RE: New Dwelling: Board Review of Habitable Space Increase
117 Samoset Avenue
Wellfleet, MA

On behalf of our clients Beth Falk and Raul Marques-Pascual, J. M. O'REILLY & ASSOCIATES, INC. is requesting the Board of Health review and approve the new floor plans for a new dwelling for and new Variances for the PROPOSED NITROE sewage treatment system. The Site & Sewage Disposal System Plans dated 9/10/2021 and revised thru 12/23/2022 are attached.

PROPOSED SEPTIC DESIGN
117 SAMOSET AVENUE, WELLFLEET, MA

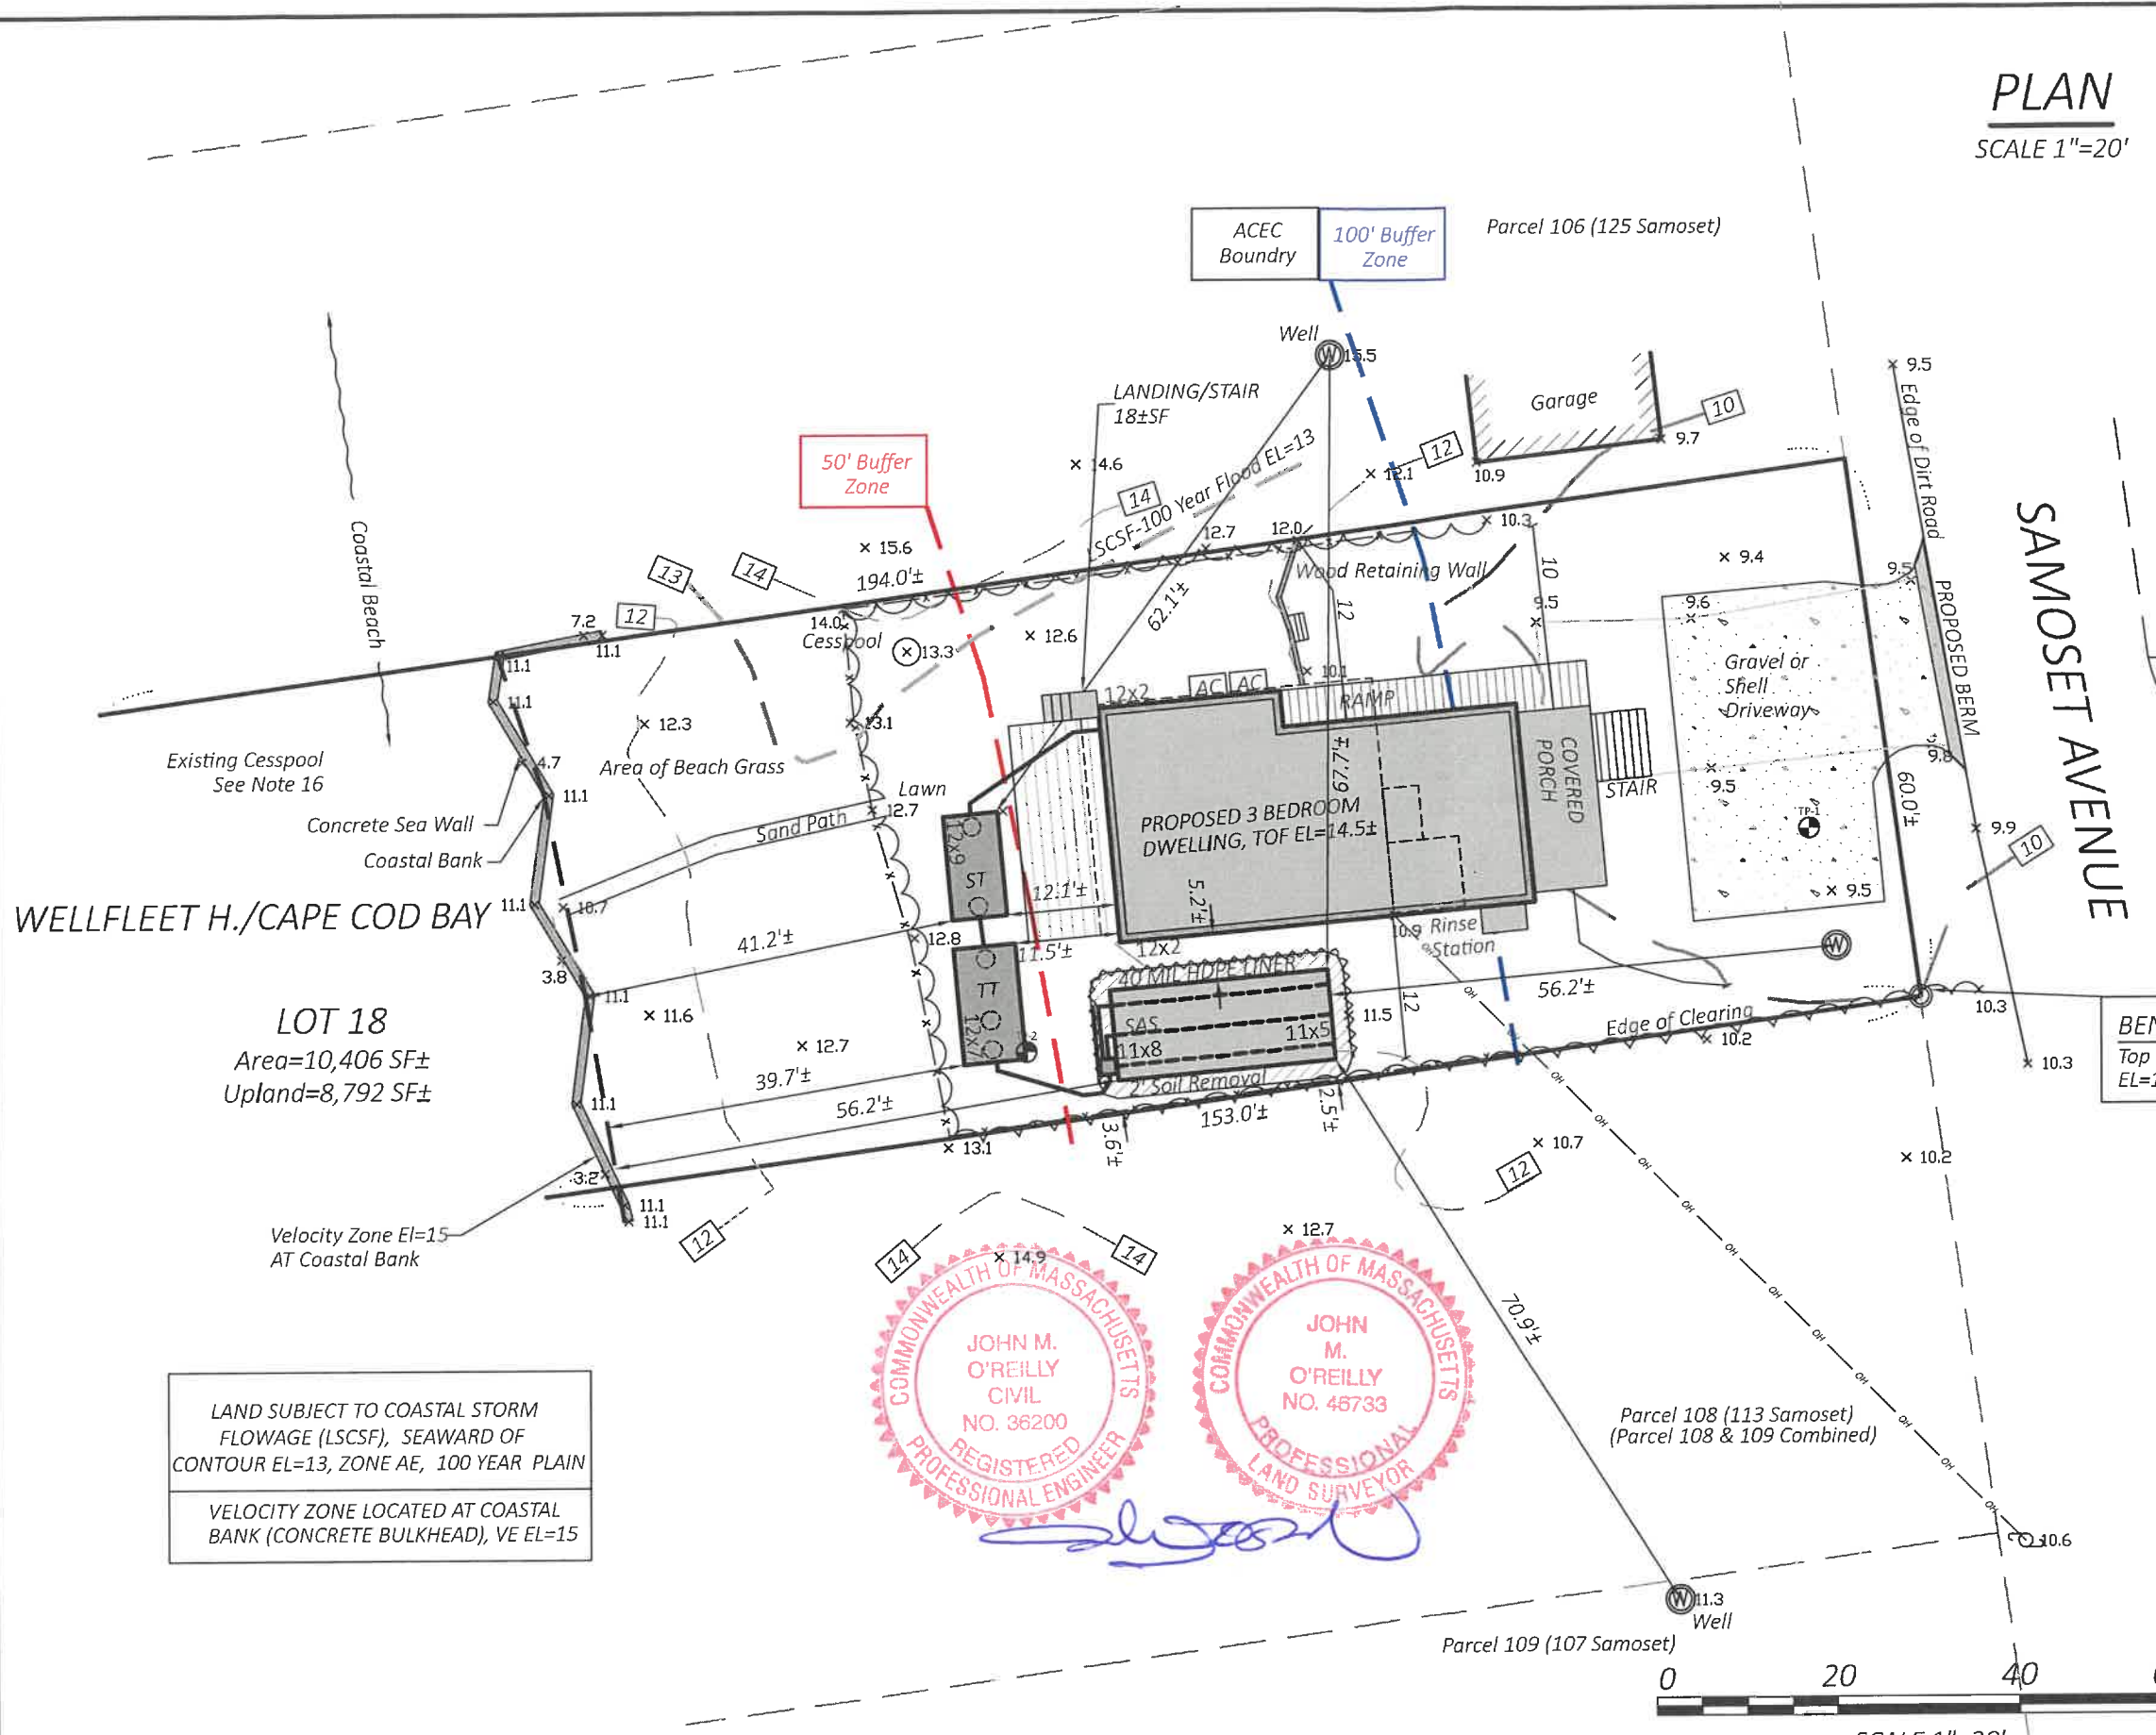
REVISED PLAN, 12/23/22: CHANGED SEPTIC DESIGN FROM FAST IA TREATMENT TO NITROE IA TREATMENT.

REVISED PLAN, 11/10/22: ADDED STAIR ON WEST DECK, ADDED COVERED FRONT PORCH, & SQUARED OFF FRONT FOUNDATION.

A1.1

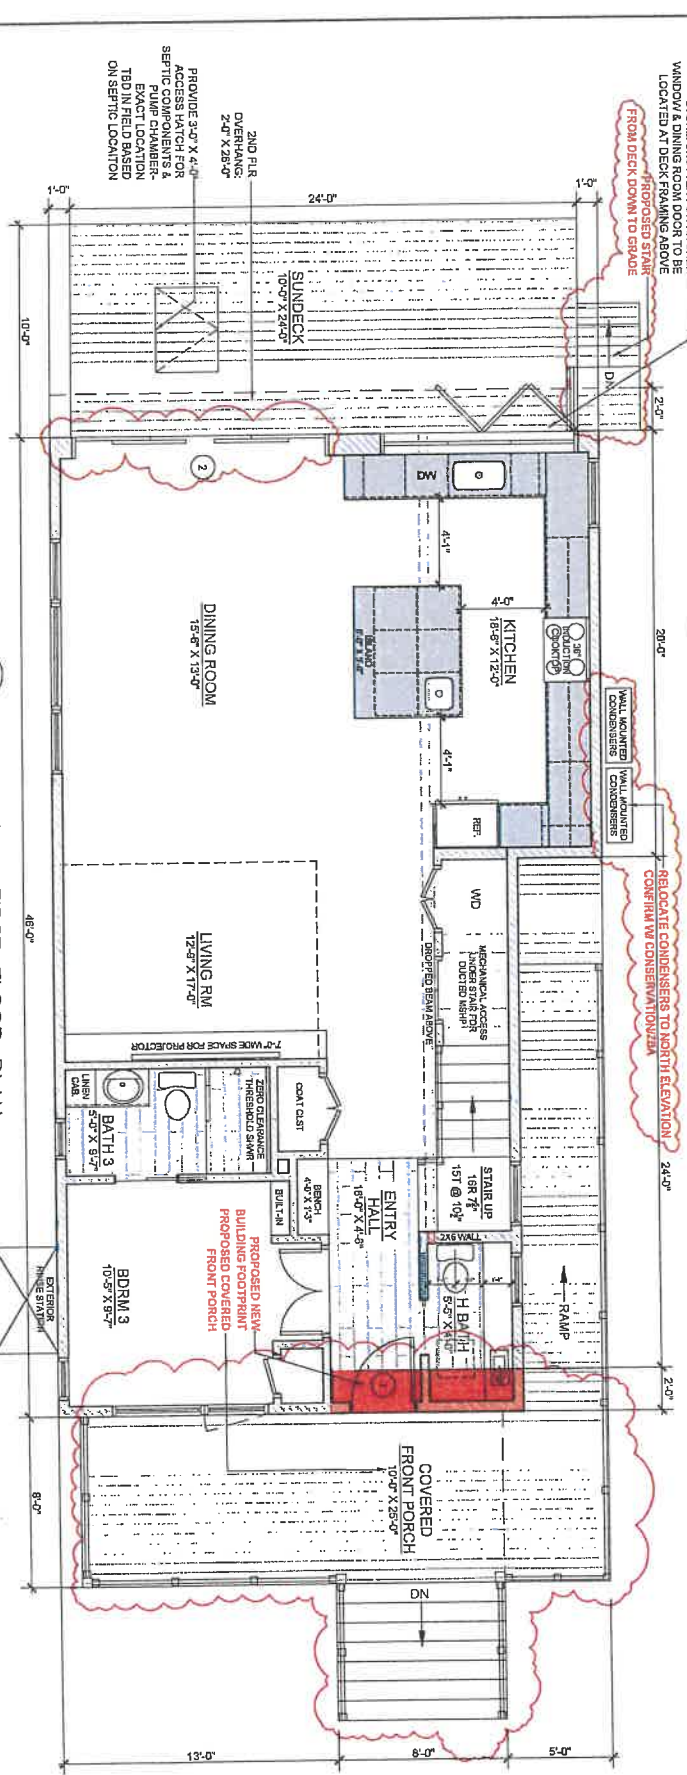
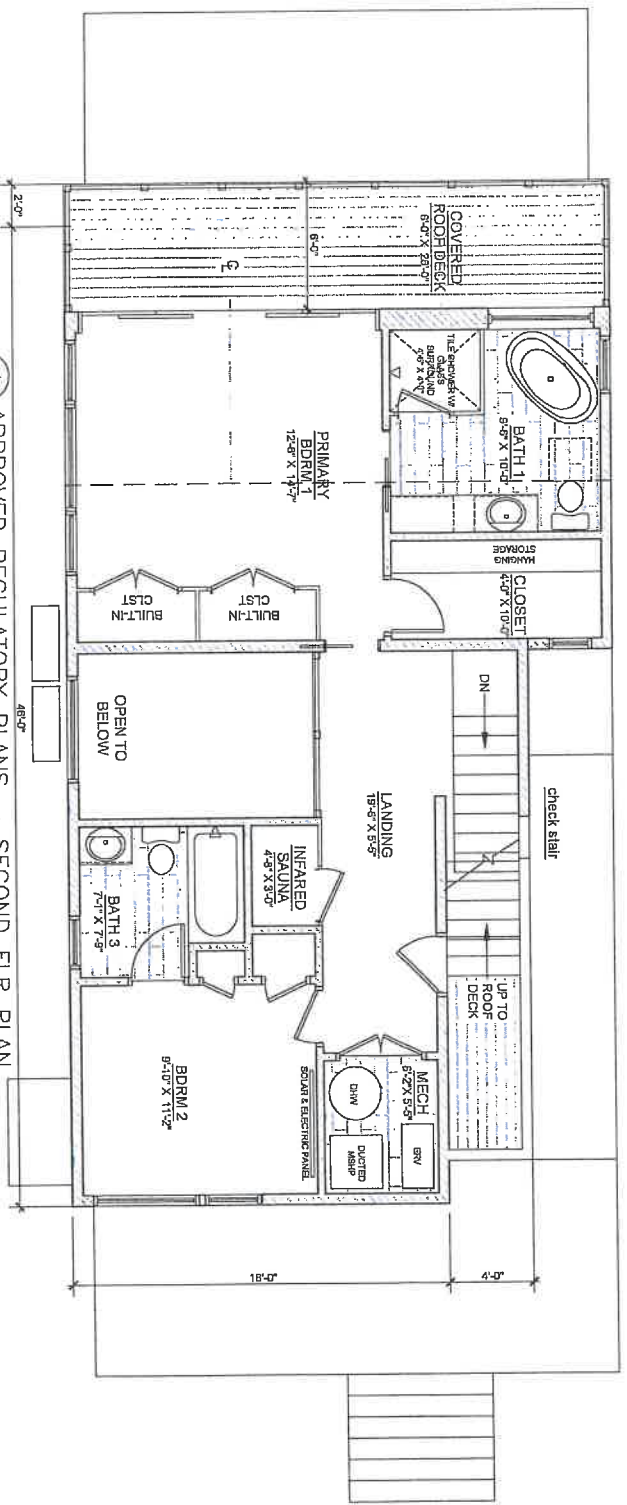
1 APPROVED REGULATORY PLANS - FIRST FLR PLAN
 A1.1 1/4"=1'-0"

2 PROPOSED - FIRST FLOOR PLAN
 A1.1 1/4"=1'-0"

A1.2

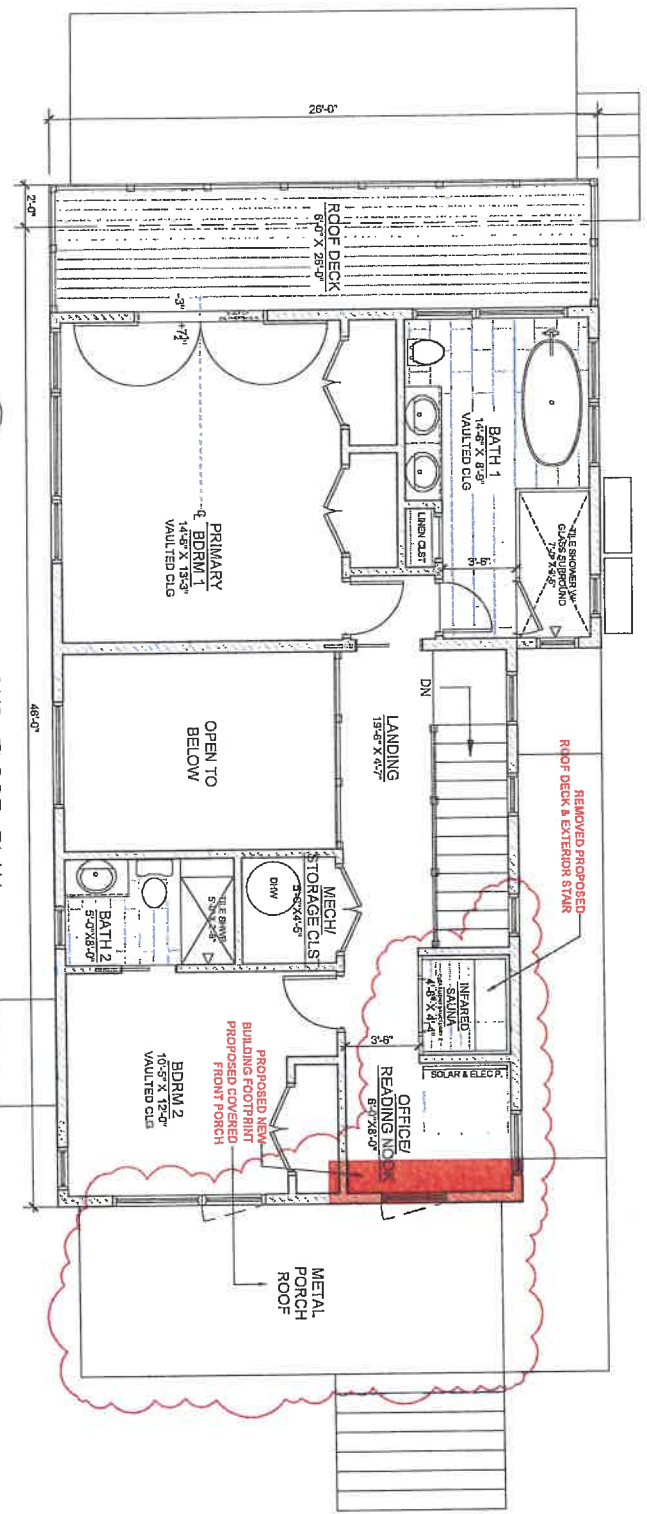
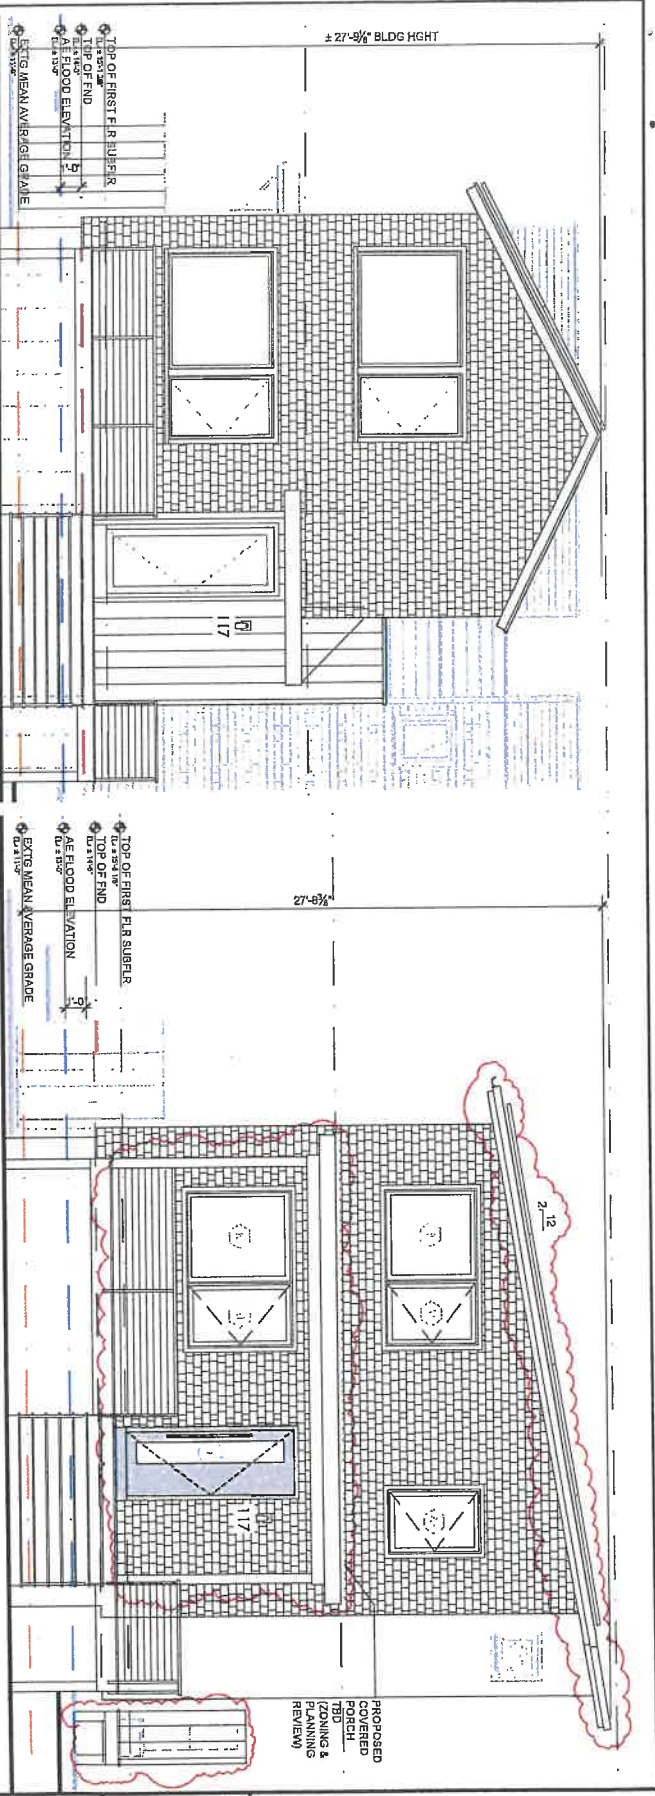
1 APPROVED REGULATORY PLANS - SECOND FLR PLAN
A1.2 1/4"=1'-0"

2 PROPOSED - SECOND FLOOR PLAN
A1.3 1/4"=1'-0"

A2.0

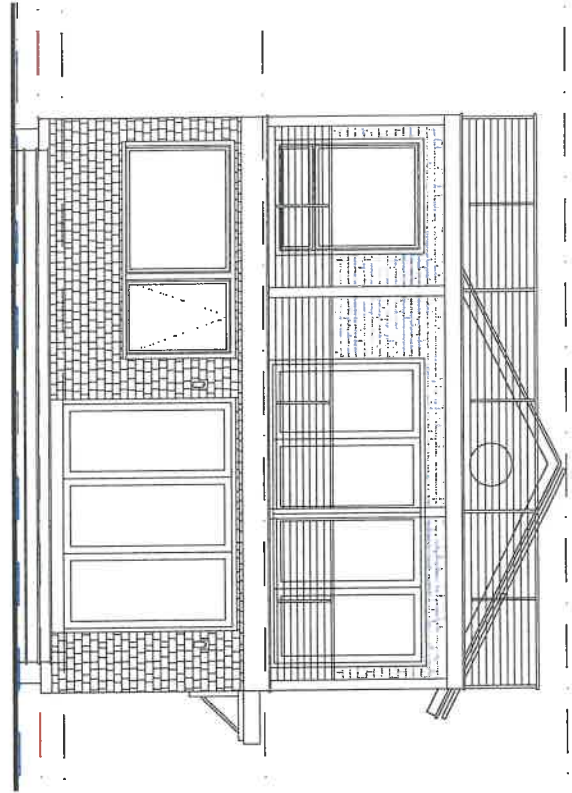
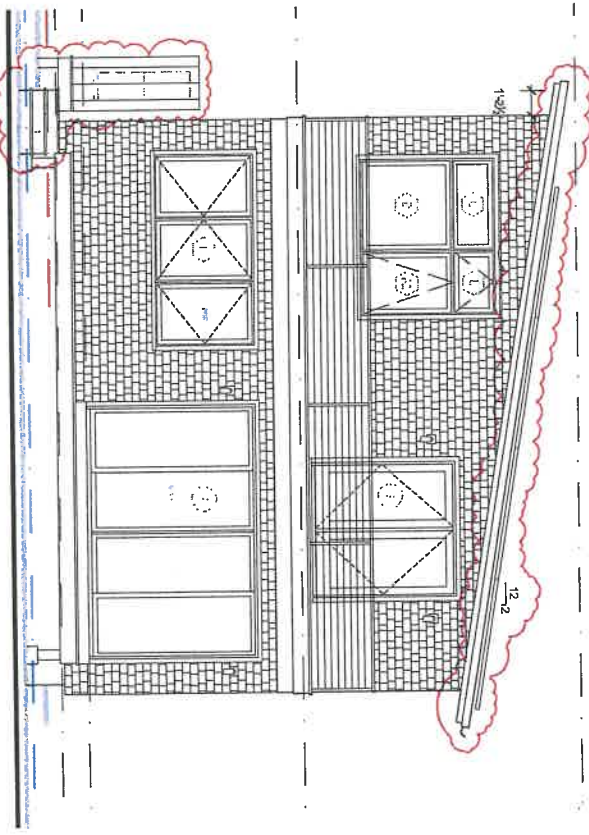
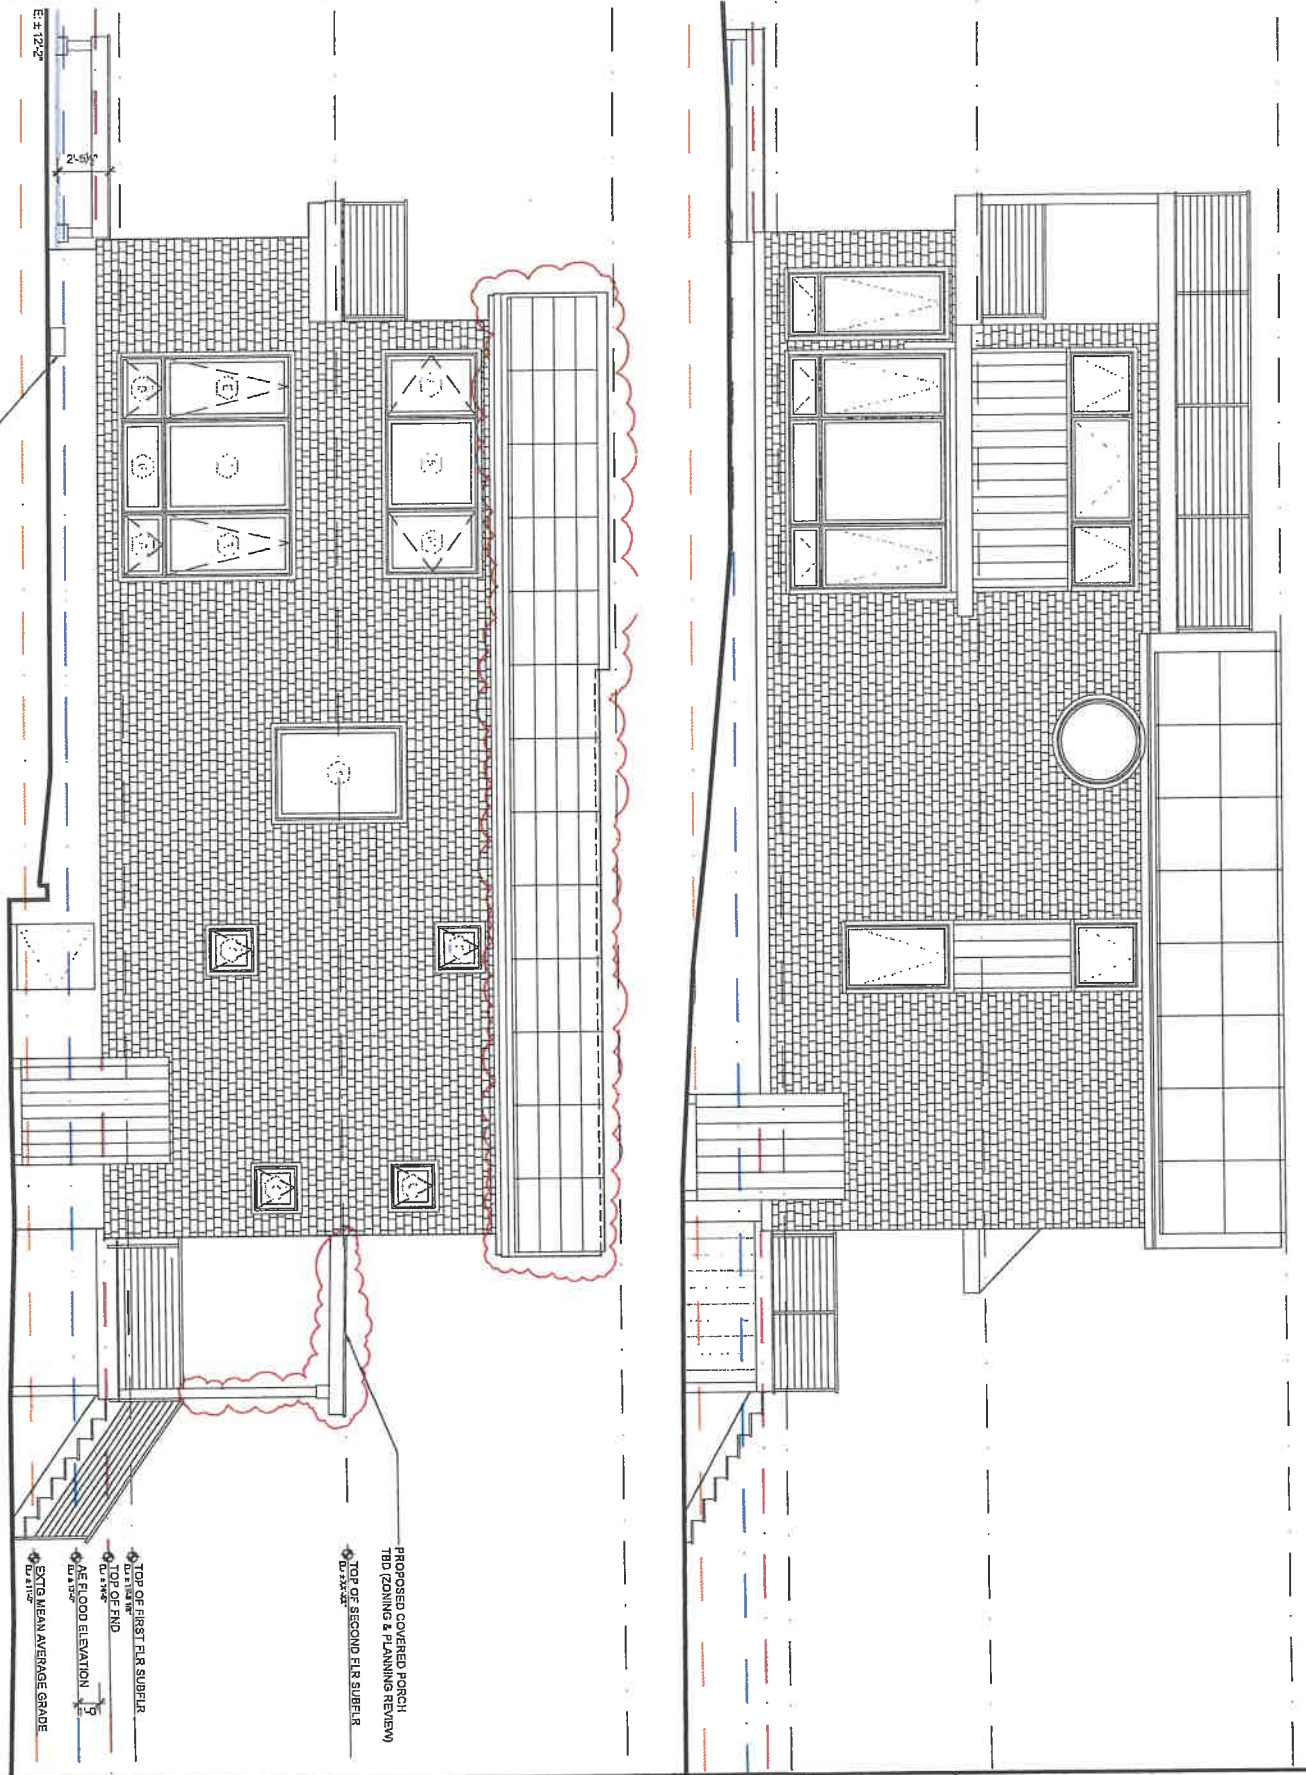
1 APPROVED REGULATORY — EAST ELEVATION (STREET)
A2.0 1/4" = 1'-0"

2 PROPOSED EAST ELEVATION (STREET)
A2.0 1/4" = 1'-0"

3 APPROVED REGULATORY — WEST ELEVATION (WATER)
A2.0 1/4" = 1'-0"

4 PROPOSED WEST ELEVATION (WATER)
A2.0 1/4" = 1'-0"
